TENNESSEE VALLEY AUTHORITY

Enclosed is our response to R. D. Walker's letter to H. G. Parris dated May 21, 1985 requesting a supplemental response for Inspection Report 84-52 for our Browns Ferry Nuclear Plant.

ENCLOSURE  
SUPPLEMENTAL RESPONSE  
NRC INSPECTION REPORT NOS.  
50-259/84-52, 50-260/84-52, AND 50-296/84-52  
ROGER D. WALKER'S LETTER TO H. G. PARRIS  
DATED MAY 21, 1985

# ASSEMBLY DETAILS OF LIMITORQUE OPERATOR FOR FCV 74-12

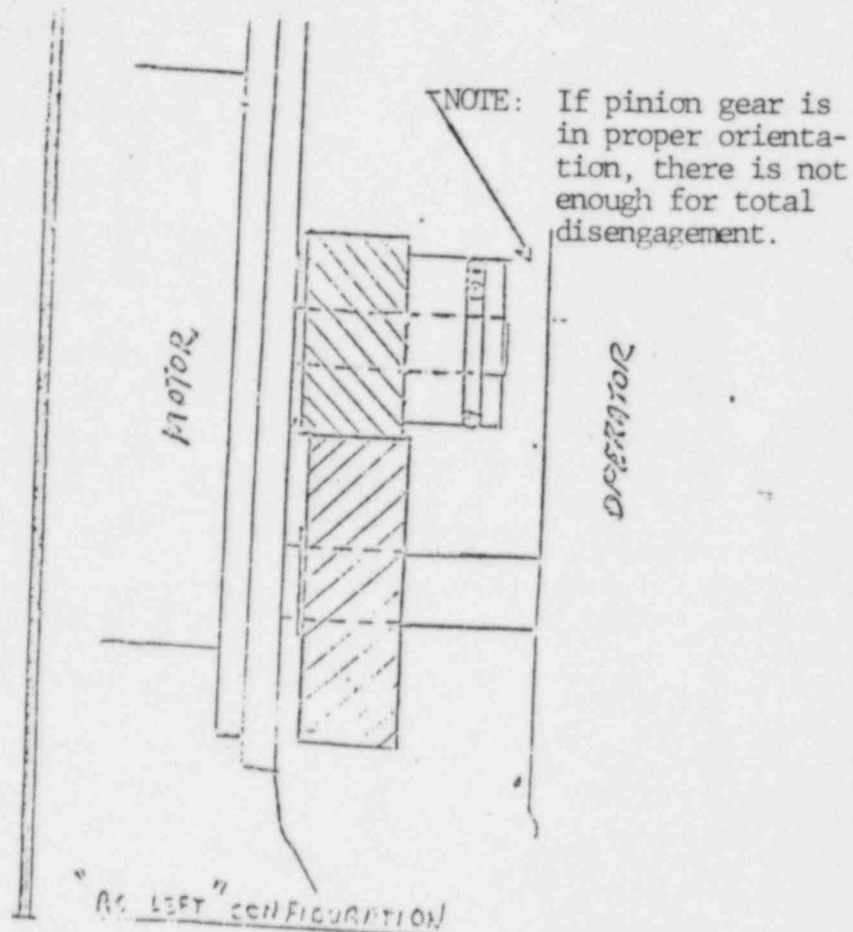
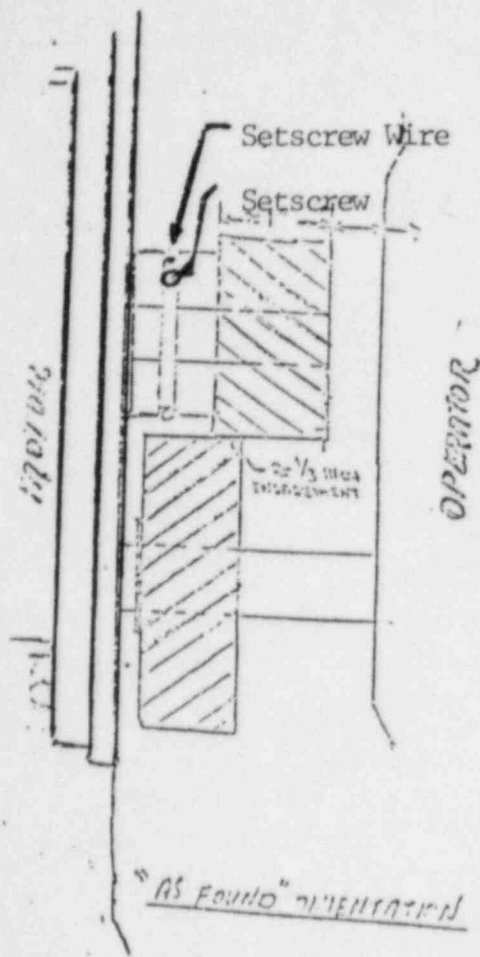
Maintenance activities associated with Limitorque operators are controlled by Mechanical Maintenance Instruction (MMI) 87 (Corrective and Preventative Maintenance of Limitorque Operators). To verify motor pinion gear orientation, an exploded view of the operator (attached) is provided in the instruction. The correct pinion gear orientation is, as shown, dependent on the size and model of the Limitorque operator involved. The craftsmen involved with verifying orientation in this case misinterpreted the sketch and, consequently, verified the orientation of the gear incorrectly.

MMI-87 is being revised to ensure that inspection requirements are clearly identified. The inspection program for Limitorque operators on emergency core cooling system valves has been increased from a 20 percent sample to a full inspection. No additional reverse gears have been found to date. In addition, a comprehensive three-day training course utilizing several different Limitorque operators has been developed by our training organization. This course involves principles of operation and "hands on" practice on these operators. Feedback from participants indicates a very good course has been developed. Craftsmen and engineers who are responsible for maintenance activities on Limitorque are receiving this training.

Sketch showing engagement between motor pinion gear and worm shaft clutch gear. Orientation shown at right is correct for a SMB-1 Limitorque operator like the one on FCV 74-12.

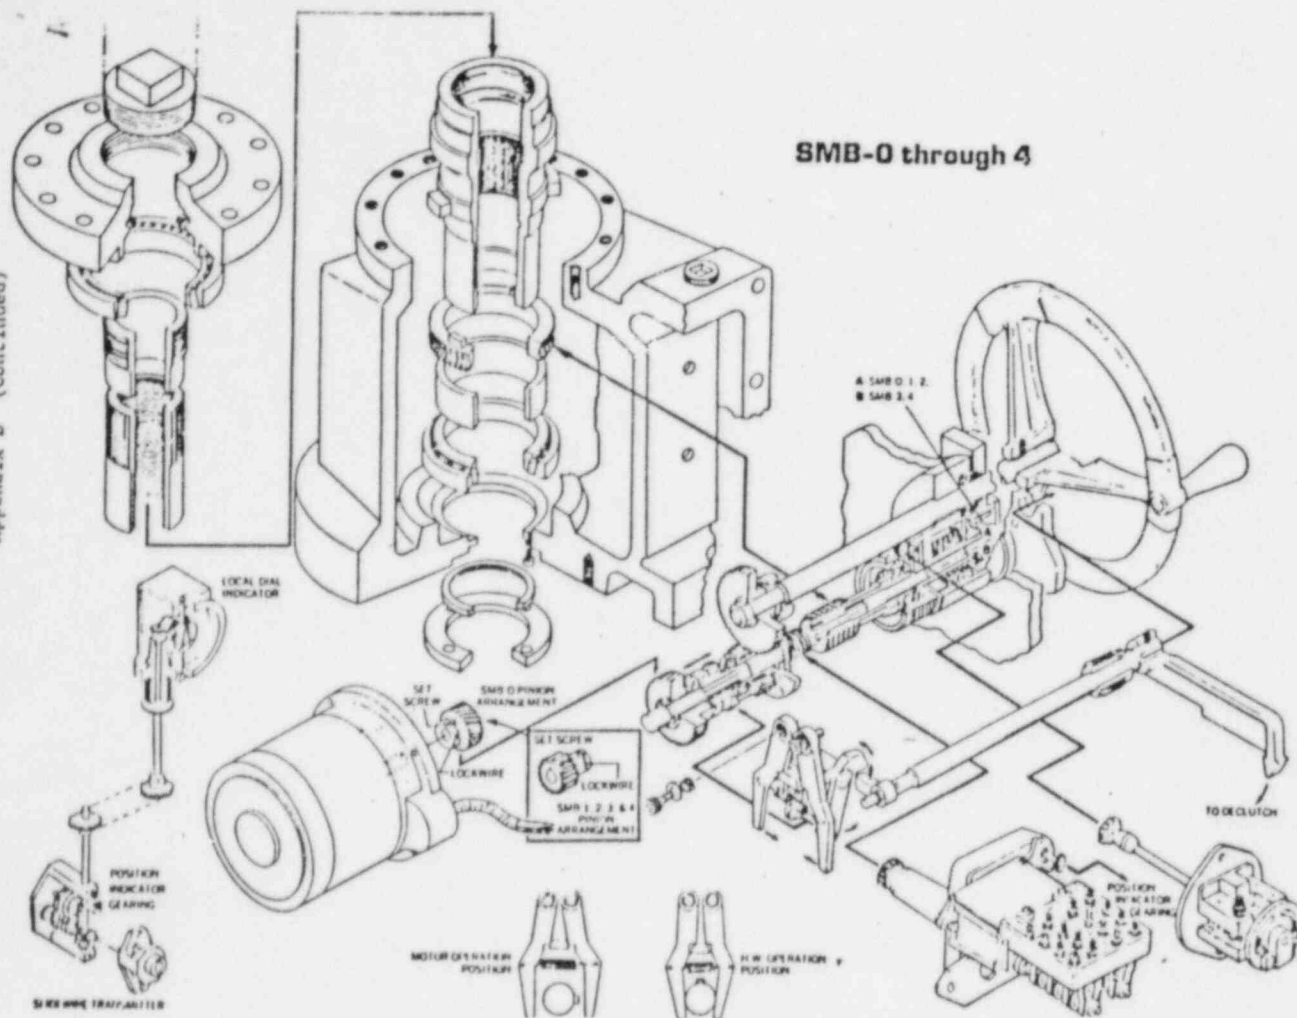
In regards to the relationship to valve operability and pinion gear setscrew tightness, it must be noted that both subject valves had motor pinion gears installed backwards. In this configuration, enough clearance is available for total disengagement of the motor pinion and worm shaft clutch gear (see attached figure).

If the pinion gear installation is correct, valve operability would only be affected if the setscrew was loose and the key slipped out of the key slot (or the key sheared). This is an unlikely situation. MMI-87 is being revised to ensure the key is kept in position (if loose) by pricking the end of the pinion key.
